TECHNICAL BULLETIN

No: LTB00041
Issue: 2
Date: 24 May 2007

SECTION: 303-03D

Reduced Power Under Load Possible DTC P0096 and/or P2601 Stored

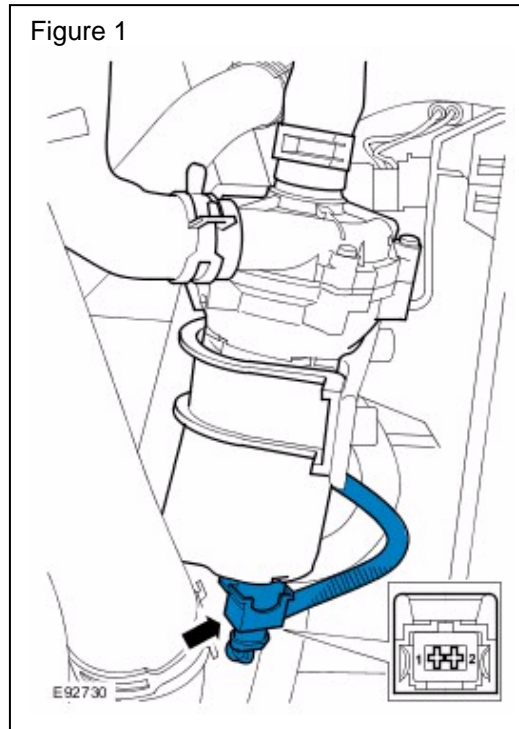
1. Release the connector locking tab and disconnect connector C3006 from the coolant pump (Figure 1)

2. Inspect the wires to determine if they are crossed.

Correct orientation Range Rover Sport (LS) is:

- Black (B) wire in Cavity 1 connected to "-" pump connection
- Brown and Purple (NP) wire in Cavity 2 connected to "+" pump connection

Correct orientation for Range Rover (LM) is:

- Brown (N) wire in Cavity 1 connected to "-" pump connection
- Red and White (RW) wire in Cavity 2 connected to "+" pump connection

3. If the wires are crossed, use terminal extractor tool YRW9000010 from the Harness Repair Kit and swap cavity 1 and cavity 2 wires to the positions indicated above.
